Project 86-060-24  
December 1990

# Response to Comments and Proposed Reclamation Plan Modifications

Church Rock Site  
Gallup, New Mexico

United Nuclear Corporation  
Gallup, New Mexico

DATE: 11-12-90	FIGURE 2-6	DRAWING NUMBER 88-060-8421
SCALE: AS SHOWN

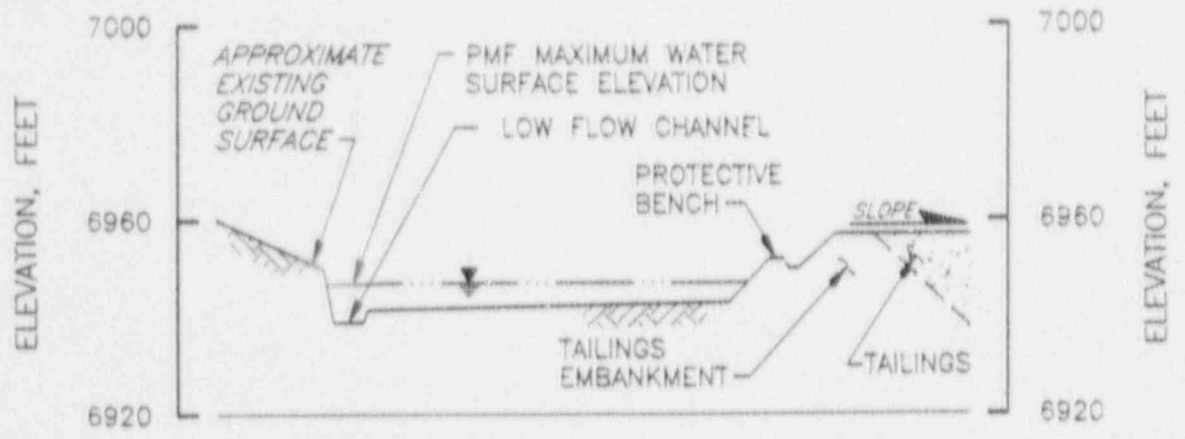
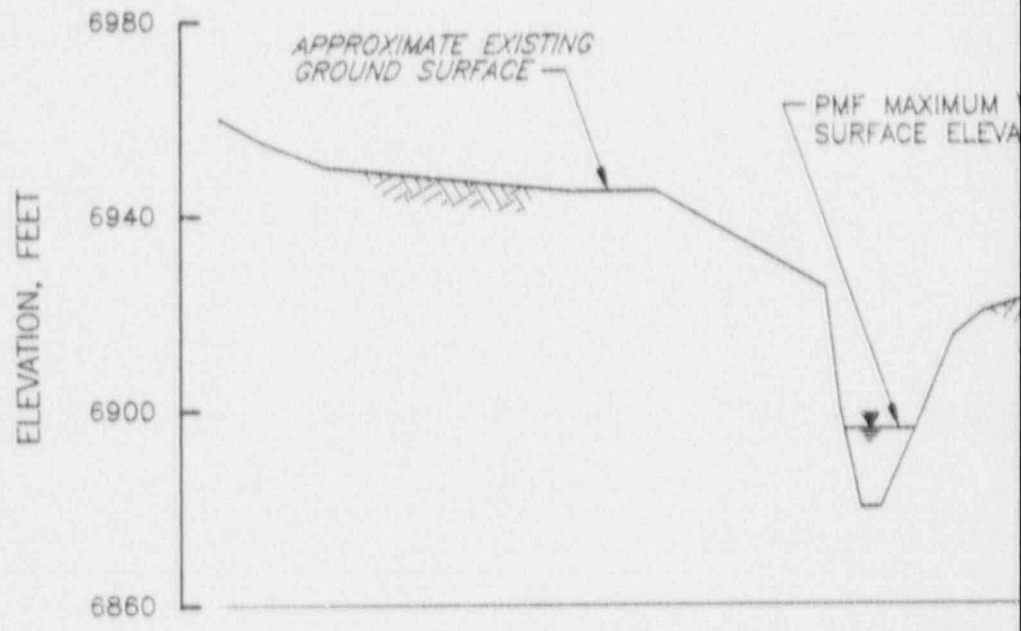
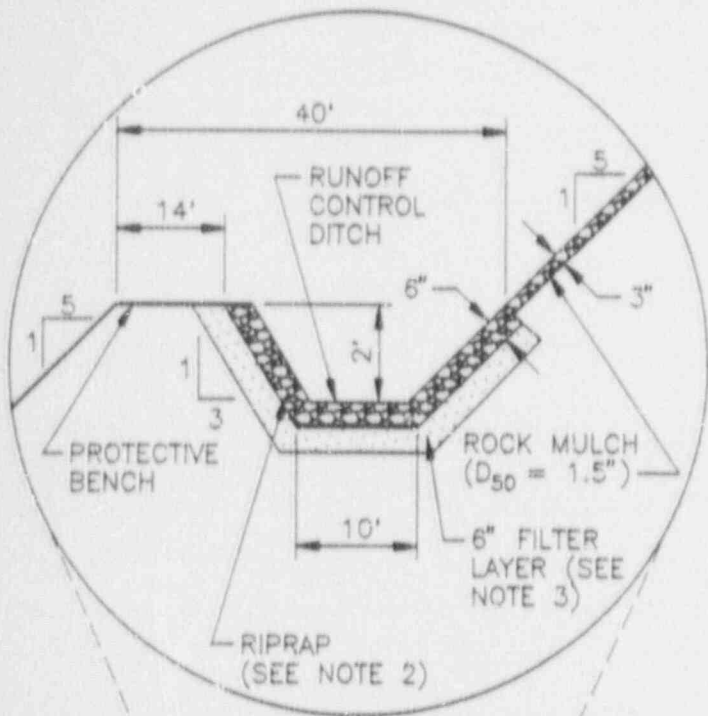
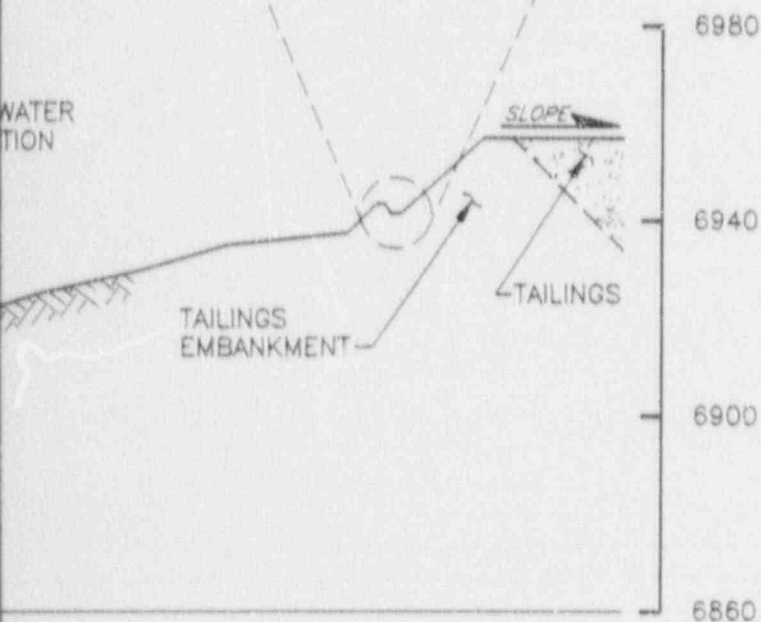
The runoff control ditch, located on the protective bench, would also be located between the embankment toe and the Pipeline Arroyo channel. The top of the protective bench would be 40 feet wide and up to 20 feet higher than the Pipeline Arroyo channel bank. Figure 2-4 shows the profiles of the bench toe, bench top, and embankment top. Figures 2-5 and 2-6 provide several cross sections that illustrate the spatial relationship between these features as well as the Pipeline Arroyo channel. Figure 2-6 provides a detail of the runoff control ditch.

The evaluation indicated that the maximum lateral bank scour to be expected during the passage of the PMF was 4.9 feet. As shown on Figure 2-6 the runoff control ditch would be located 14 feet from the protective bench edge, and the tailings embankment toe is 40 feet from the protective bench. Thus, the PMF would not contact either the runoff control ditch or the tailings embankment toe.

DATE: 11-14-90	FIGURE 2-7	DRAWING NUMBER
86-060-B428	SCALE: AS SHOWN	86-060-B430

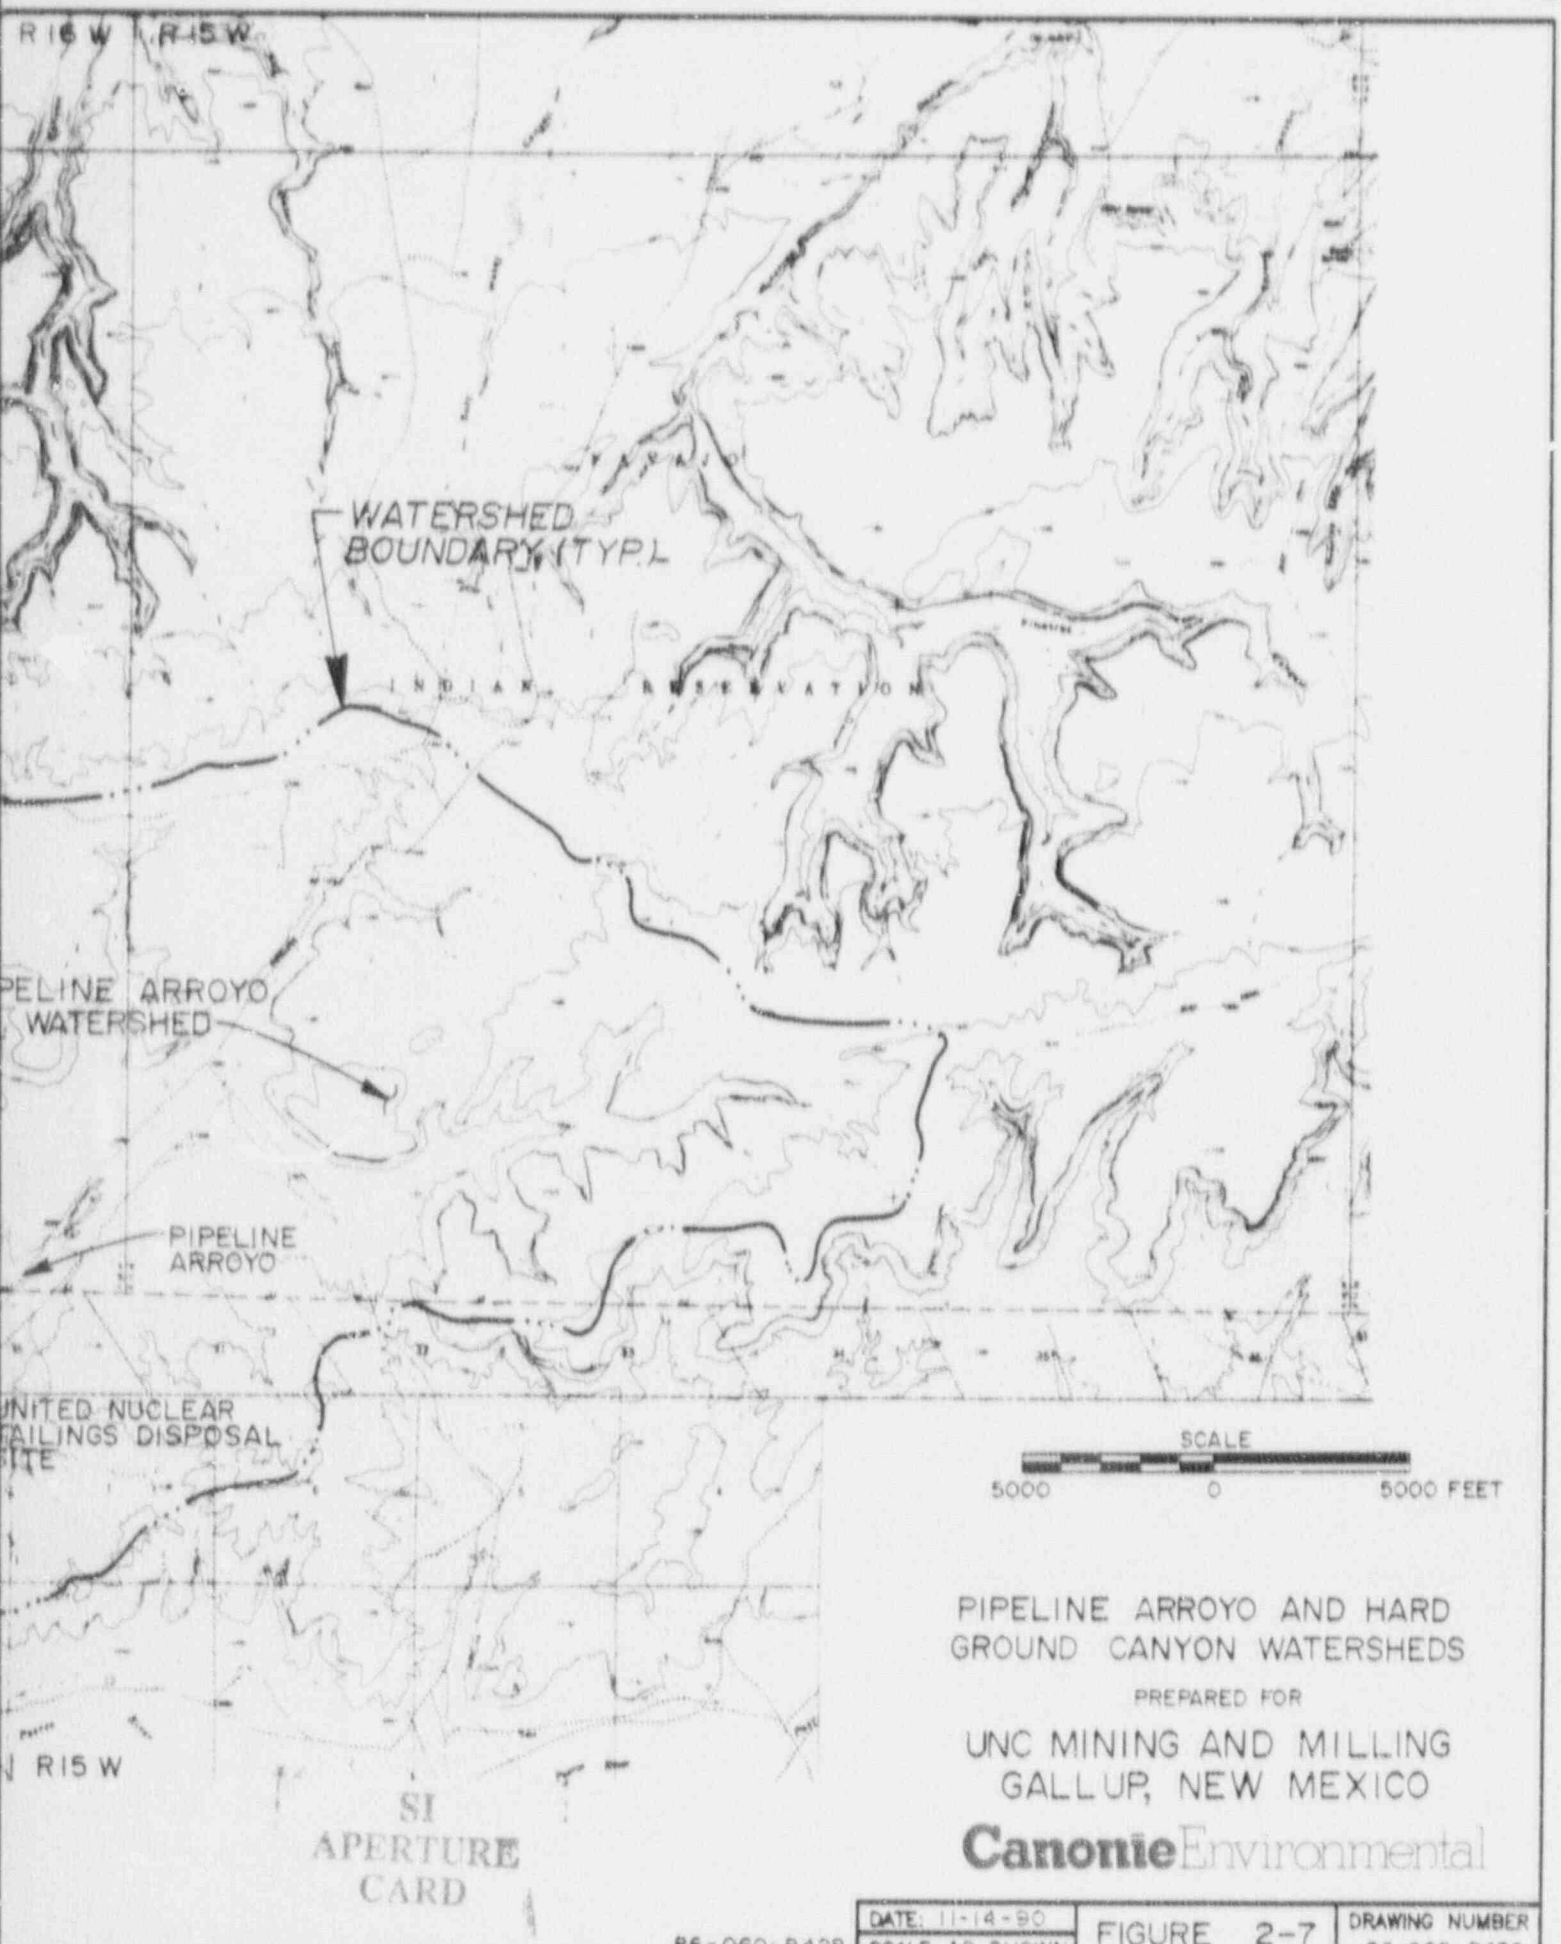
Figure 2-7 shows the channel reaches and watersheds that were characterized in the watershed known as Hard Ground Canyon, which is about 5 miles northwest of Pipeline Arroyo. The two watersheds are similar in size, soil, and vegetation characteristics. The channels that drain these watersheds are also similar in that their lower reaches are deeply incised, probably by headcutting that has migrated from downstream areas. The headcuts have been terminated by sandstone outcrops (nickpoints) that have resulted in the formation of large alluvial-fill valleys upgradient of the nickpoint. The channels upgradient of the nickpoint have shallow slopes.

DATE: 11-15-90	FIGURE 2-8	DRAWING NUMBER	△
SCALE: AS SHOWN		BB-080-E419

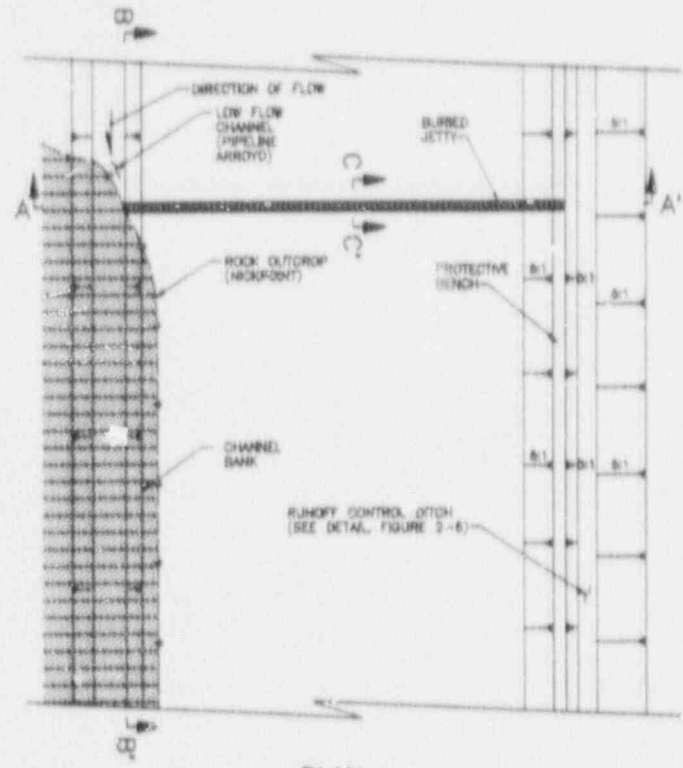
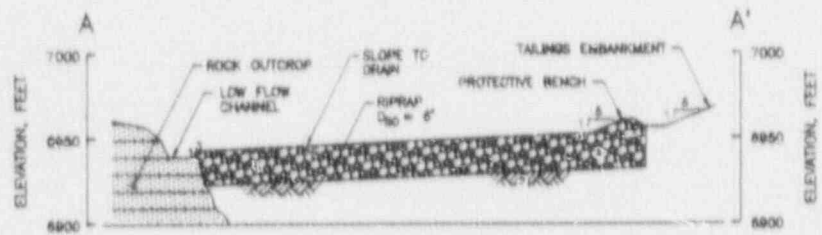
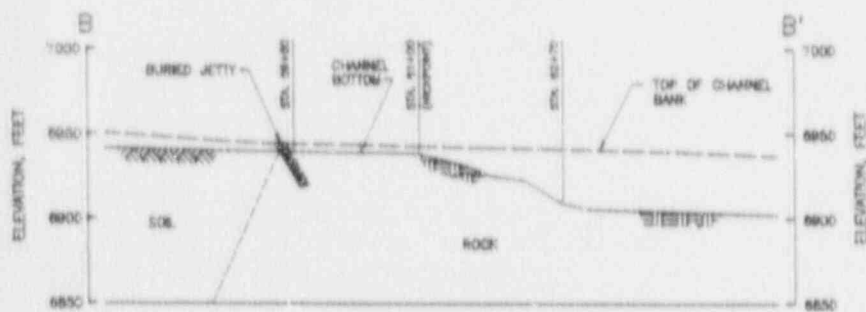
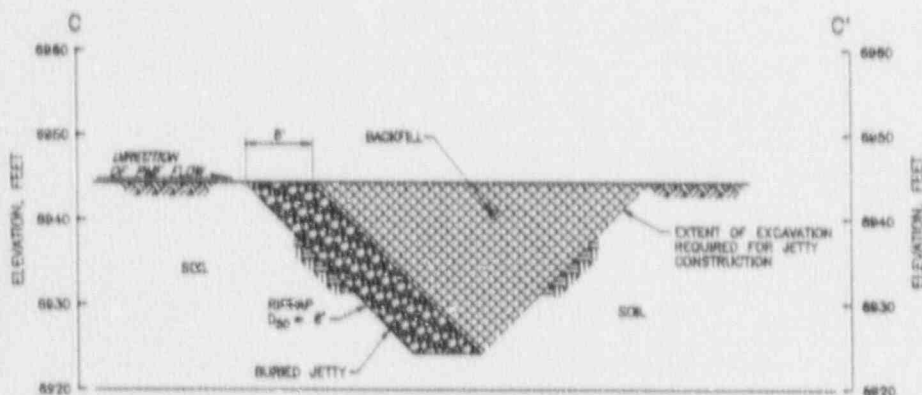
Figure 2-2 shows the location of the proposed jetty, while Figure 2-8 provides the jetty details. The jetty would be keyed into the nickpoint at its furthest extent to maximize the flow capacity within the nickpoint. The exact configuration of the eastern edge of the nickpoint will be determined in the field at the time of construction. For the present design, the low-flow channel was considered to be 30 feet wide and located at the west terminus of the jetty. The low-flow channel may be wider, depending on the nickpoint configuration.

As shown on Section B-B' of Figure 2-8, any potential headcuts would have to start at least 150 feet downstream from the proposed jetty at the beginning of Reach 3. The low-flow channel remains stable for this distance at a constant low slope on the rock of the nickpoint. Thus, the propensity for creating headcuts would not exist in the first 150 feet below the jetty because any flows in the overbank area would be traveling parallel to the channel banks.

Headcuts that could affect the toe of the proposed jetty would have to start at least 308 feet downstream from the proposed jetty. As shown on Section C-C' of Figure 2-8, the toe of the jetty would extend downward to an elevation of 6,923 feet at Station 59+70. Assuming a headcut channel slope of 0.01 ft/ft, a potential headcut would have to form at or below Station 62+78 where the Pipeline Arroyo channel bottom is at elevation 6,920 feet to be able to be below elevation 6,923 feet at the toe of the proposed jetty. The distance this potential headcut would have to migrate is about 308 feet from Station 62+78 to Station 59+70.

DATE: 11-12-90	FIGURE 2-9	DRAWING NUMBER 86-060-8423
SCALE: AS SHOWN

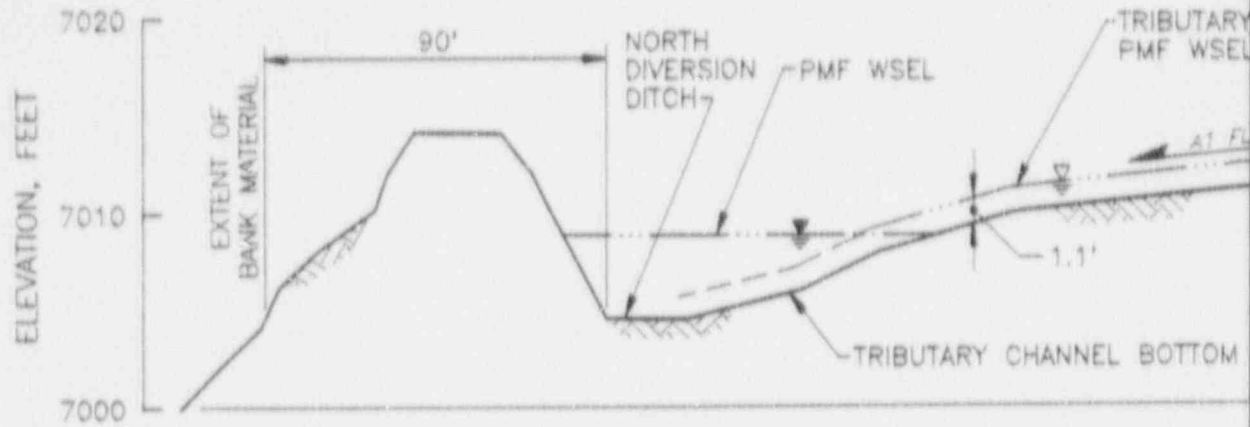
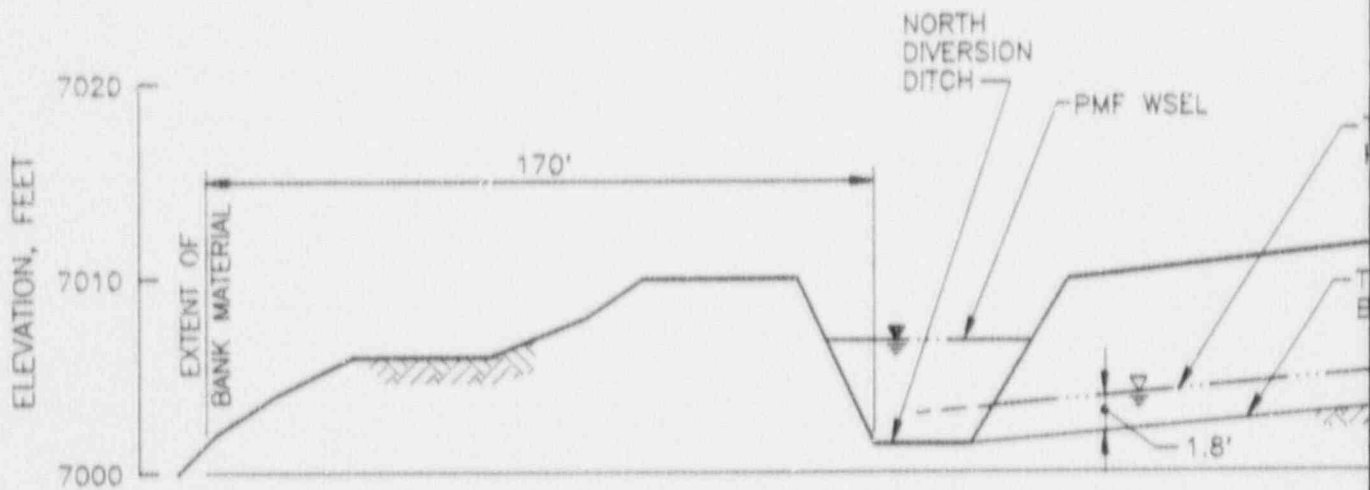
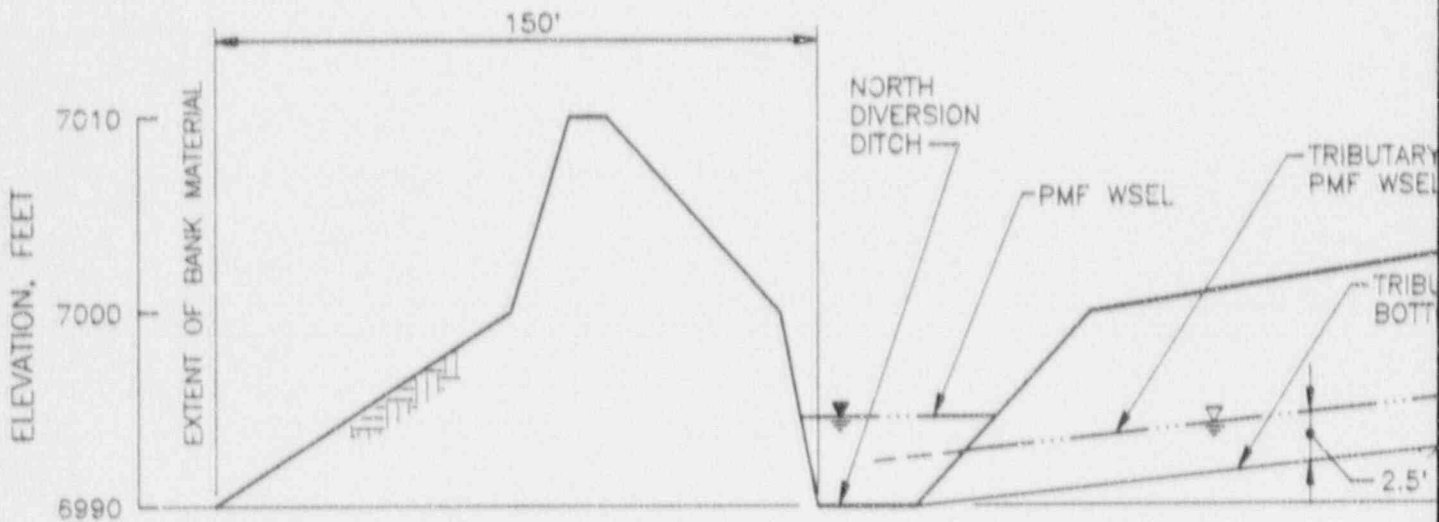
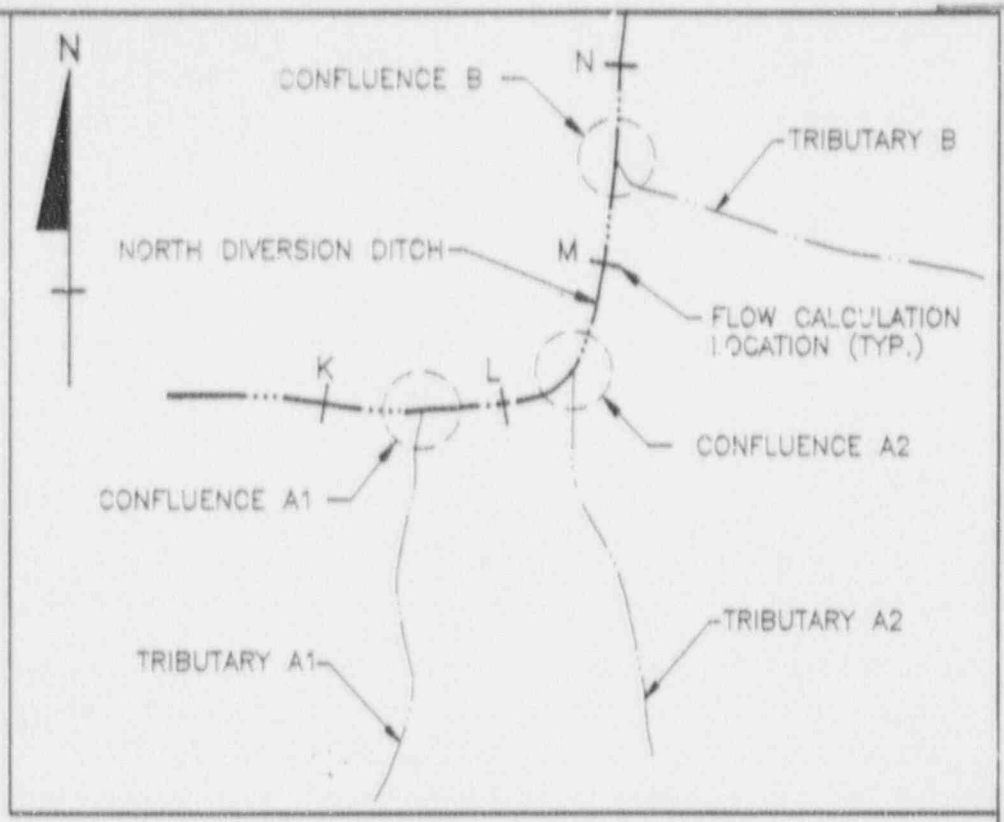
Figure 2-9 provides a schematic of the tributaries and related cross sections on the North Diversion Ditch. Table 2.8 provides a summary of PMF flow characteristics for each of these locations. The PMF peak discharges were determined using the SCS TR55 method. Manning's equation was used to

Figure 2-9 provides cross sections of the North Diversion Ditch at the confluences. The cross sections show the extent of material that would have to be scoured before flows left the diversion ditch and passed across the tailings. These scour distances are 90 feet at confluence A1, 170 feet at confluence A2, and 150 feet at Tributary B. These distances are all sufficiently large such that channel scour would not allow flows to pass over the tailings. In addition, as channel scour removes material from the far bank during a particular flow event, the channel would become wider and thus protect itself from future scour.
